CROWN CEMETERY DEVELOPMENT APPLICATION - VARROVILLE

Response to IPC queries

RESPONSE TO SUBMISSIONS

Figure 4 – Painting from Rudolph Ackermann's *Repository of the Arts* showing 'Drawing Room Window Curtain' (caption indicated in red), an illustrated British periodical published from 1809 to 1829

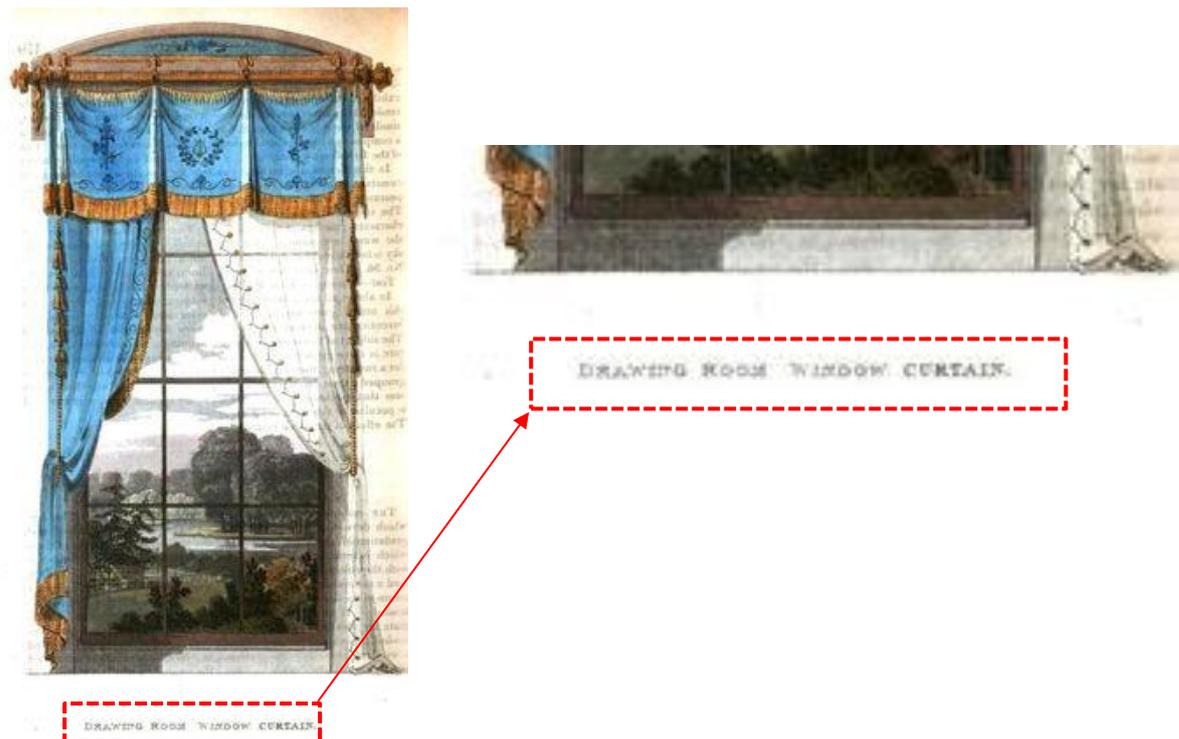
3. Mr. Gibbs asserted that the proposal has not taken into account the significance of a view from one of the rear, northern wing windows of the Varroville Homestead, view facing north-west towards the western dams (modified / constructed by the Jackamans in the mid-20th Century). Mr. Gibbs has supported his argument by including the following image (refer Figure 4), suggesting that this demonstrates that the subject view is a significant heritage view, an important planned landscape vista and a specific consideration in locating and laying out the Varroville Homestead, (the concept of which is reputedly demonstrated by the illustration). We make the following comments in response to Mr. Gibbs' assertion, based on our own research

- The view from a window provided in Mr. Gibbs' presentation does not relate to Varroville Homestead and is misleading with respect to current views. The painting which Mr. Gibbs refers to does not demonstrate significant views from houses towards particular landscape features, as he might suggest, and is in fact taken from Rudolph Ackermann's *Repository of the Arts* from the early nineteenth century, which demonstrates fashionable window dressings of the period, and therefore the provided external view is not relevant (refer Figure 4).
